Hydro One Networks Inc.

EB-2007-0050 – Hydro One Networks' Section 92 Bruce - Milton Transmission Reinforcement Application – Hydro One Networks' Response to Interrogatory Questions from Saugeen Ojibway First Nations

Saugeen Ojibway First Nations INTERROGATORY #1 List 1

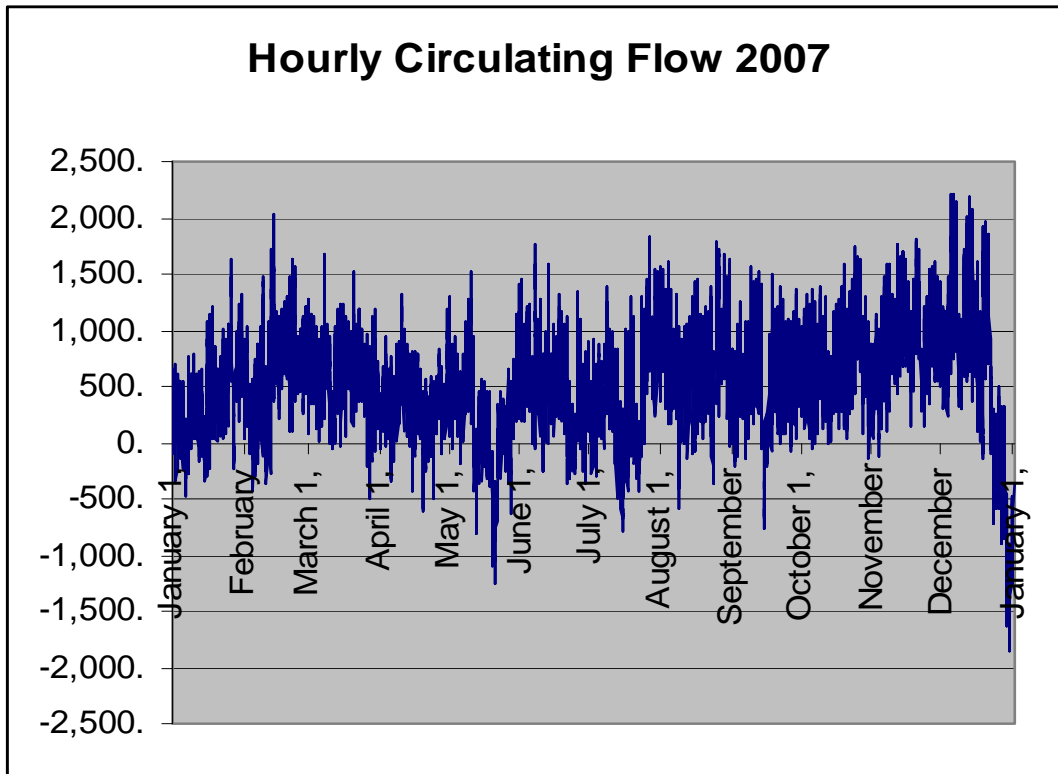
Please state the forecast amount and direction of circulating loop flow on the 500 kV and 230 kV lines emanating from the Bruce Complex during peak summer conditions for (i) each hour of the historical period since January 1, 2006 and (ii) peak summer conditions projected for the years 2008 through 2014.

For the purpose of responding to this Interrogatory, circulating loop flow has been defined as the difference between Michigan measured flow and Michigan scheduled flow. The hourly circulating flow for 2006 and 2007 are illustrated below:

Positive numbers represent counter-clockwise flow (i.e. from Ontario to Michigan south of Lake Erie and then back into Ontario through Niagara). Negative numbers represent clockwise flow (i.e. from Michigan to Ontario north of Lake Erie and then back into New York/Michigan through Niagara). As noted in the response to Interrogatory Saugeen No. 6(b), installation of new phase shifters is expected to have the capability to block about 600 MW of circulating power flow. This is expected to cause a downward shift of 600 MW in the above charts.

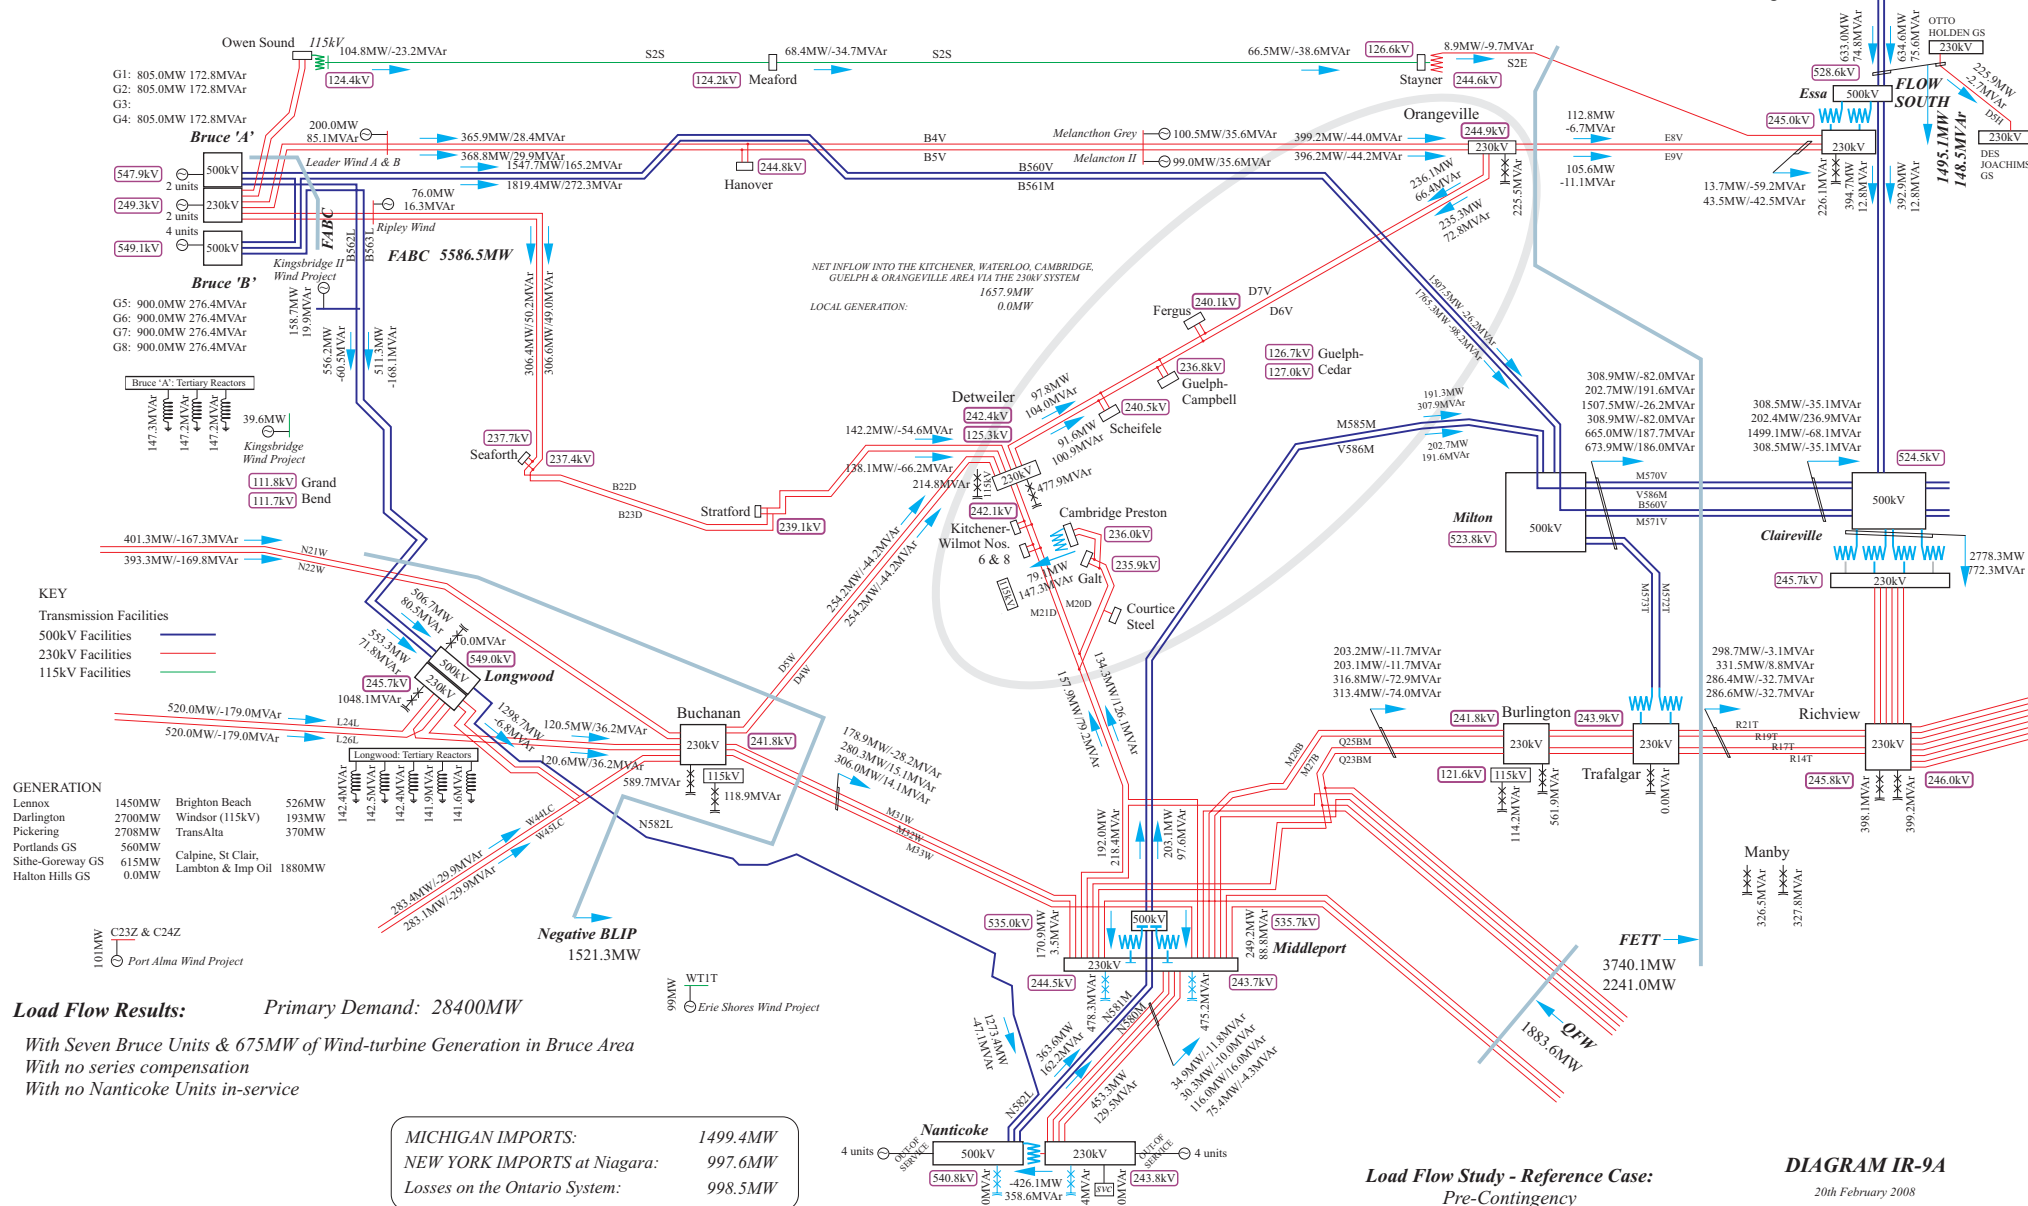
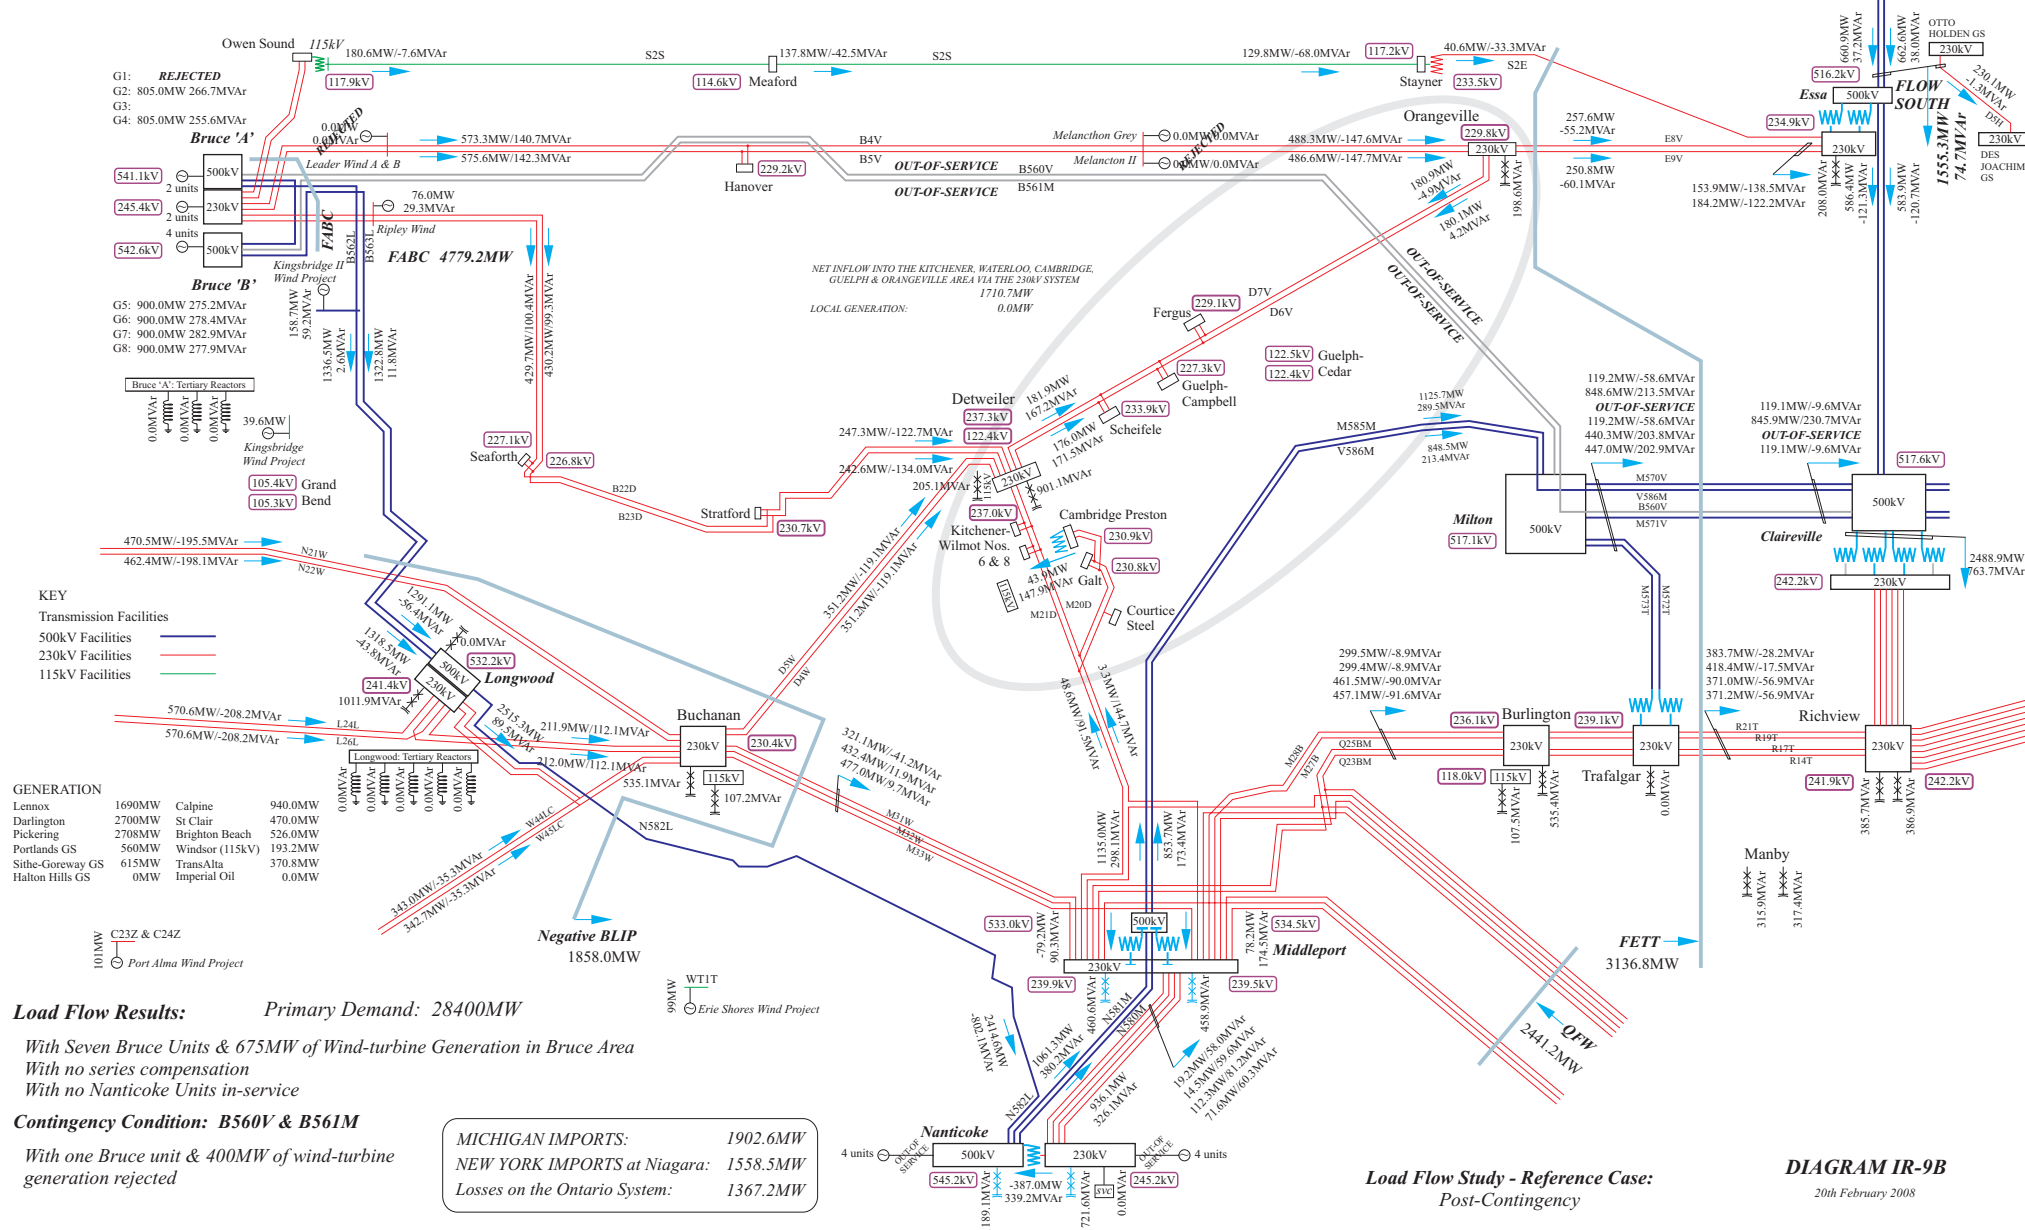
Please provide all studies (by the IESO or others) that support the claim that generation rejection ("OR") of up to two Bruce units will increase the effective transfer capability out of Bruce to about 6,700 MW, as stated in Exhibit B, Tab 6, Schedule 5, Appendix 5 at page 51 (Ontario IPSP, Discussion Paper 5: Transmission).

1 Following the completion of the interim measures, the maximum amount of generation
2 capacity that could therefore be accommodated within the Bruce area if post-contingency
3 generation rejection of one Bruce unit and the 400MW of wind-turbine capacity were to
4 be used, would total 6325MW, consisting of:
5

6
7 The results from the analysis supporting this transfer capability have been summarised in
8 the attached Diagrams A & B for the pre- and post-contingency conditions, respectively.
9

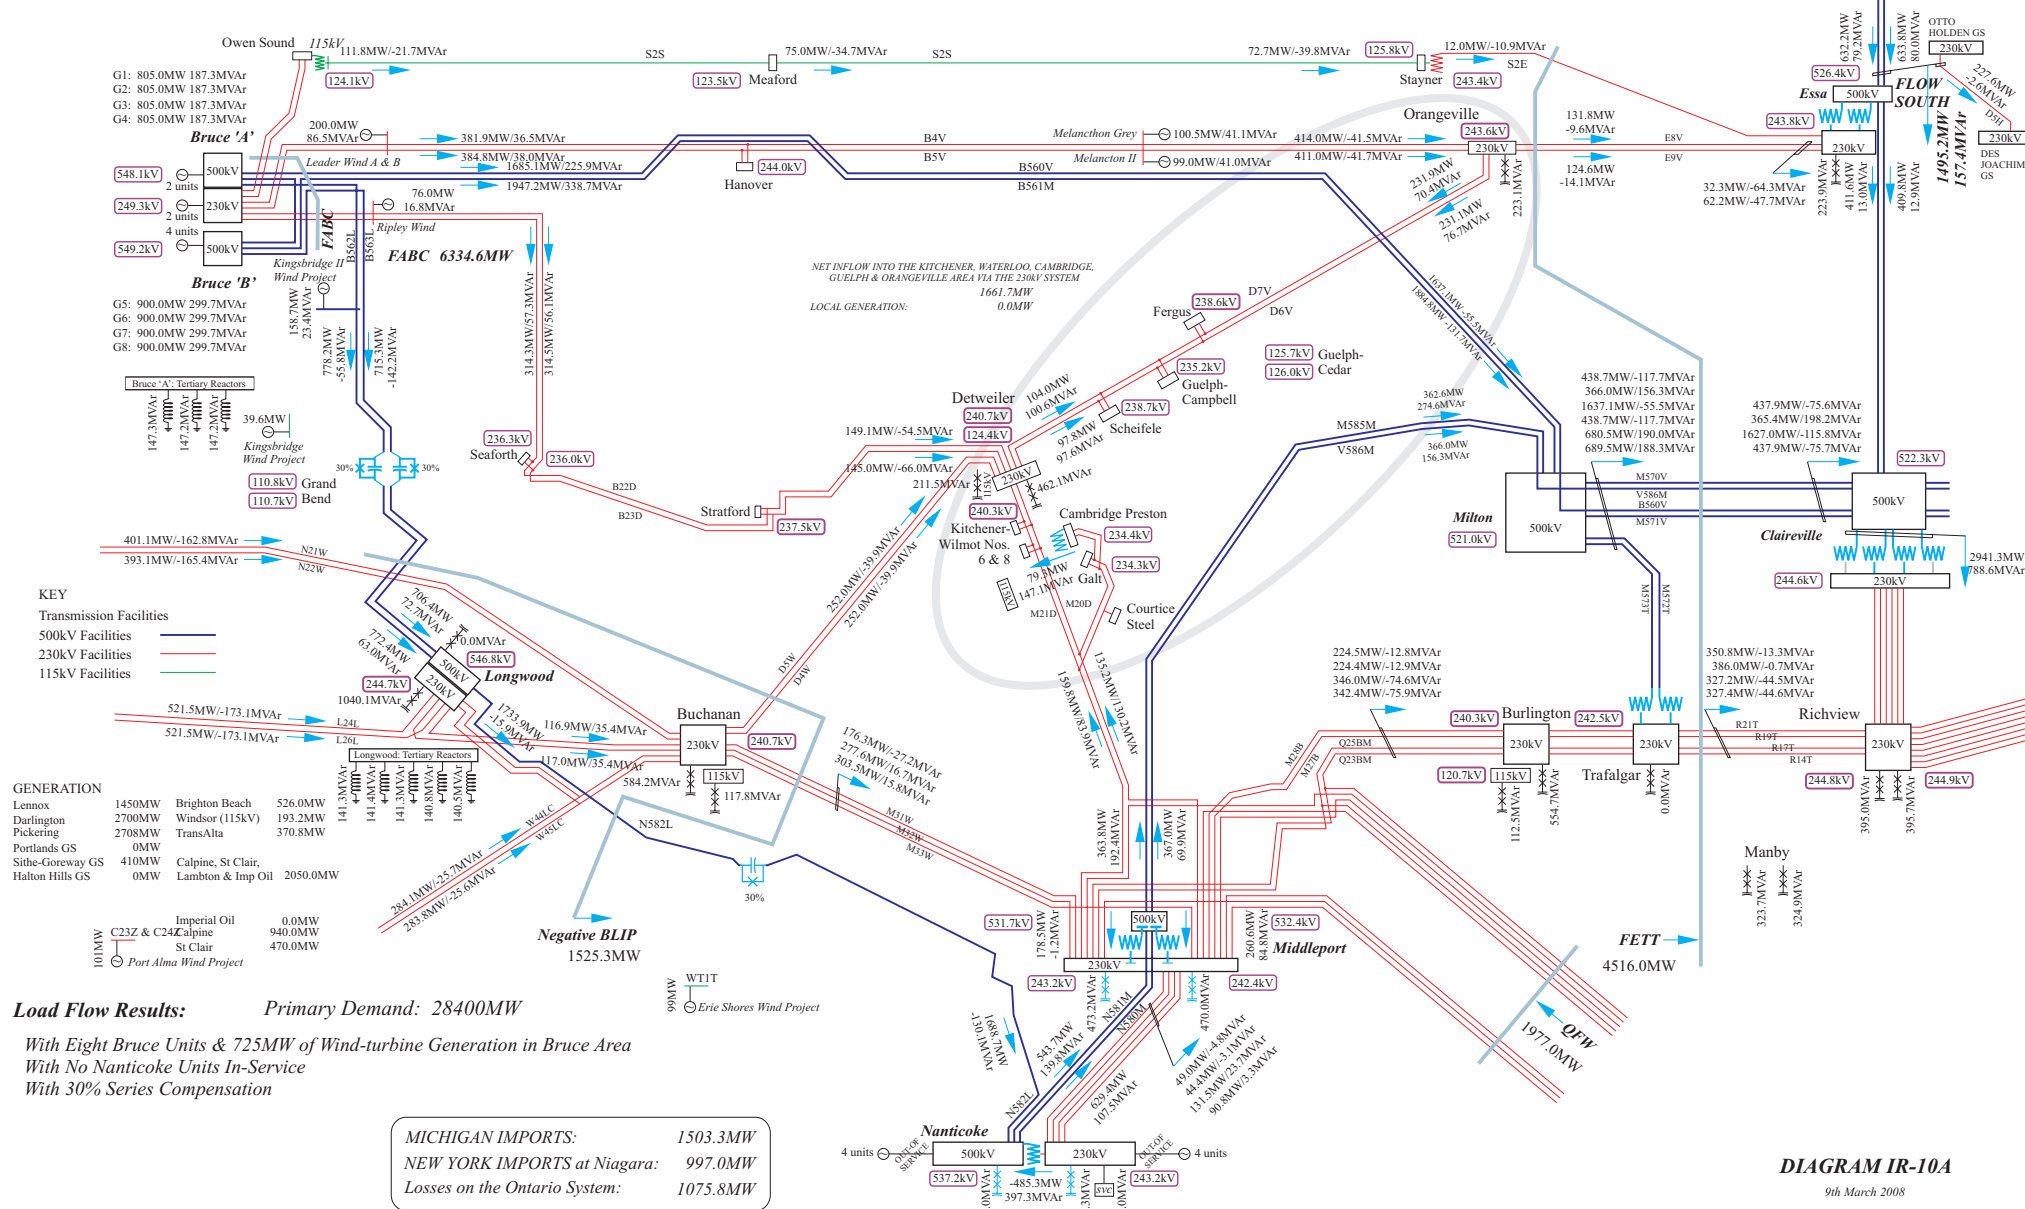
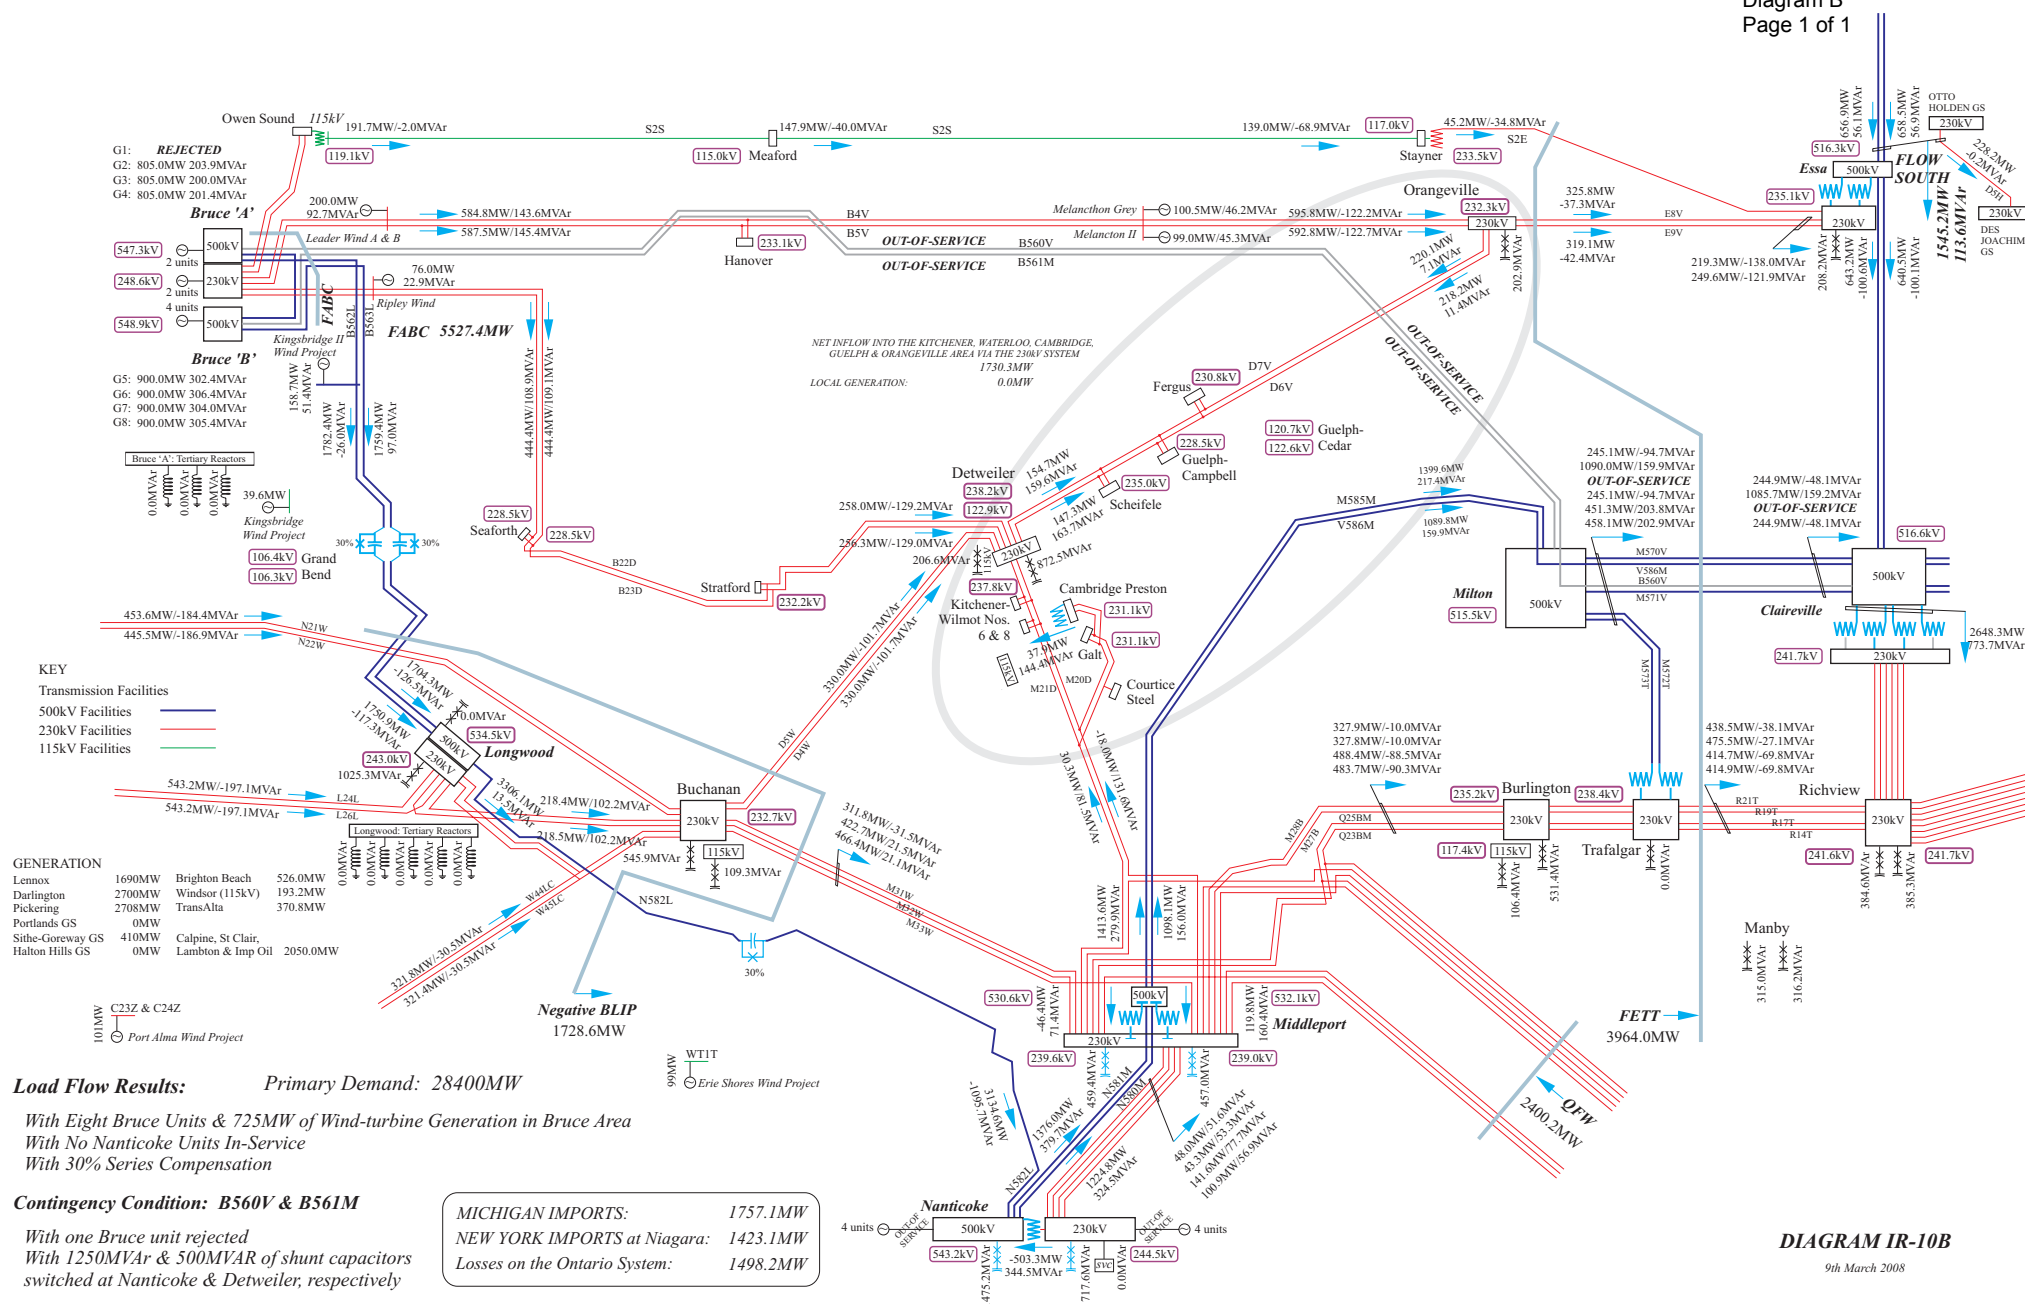
Please indicate whether IESO (or any other party) has modeled the impact upon the effective transfer capability out of Bruce using a OR of up to two Bruce Units in addition to series compensation. If such studies have been conducted, please provide the results of such studies and the load flow input data in computer readable form. If no such studies were conducted, please indicate the reason for not conducting such studies.

The results of the load flow study for the pre- & post-contingency conditions with series capacitors installed and with a single unit at the Bruce Complex rejected are shown in the attached Diagrams A & B, respectively.
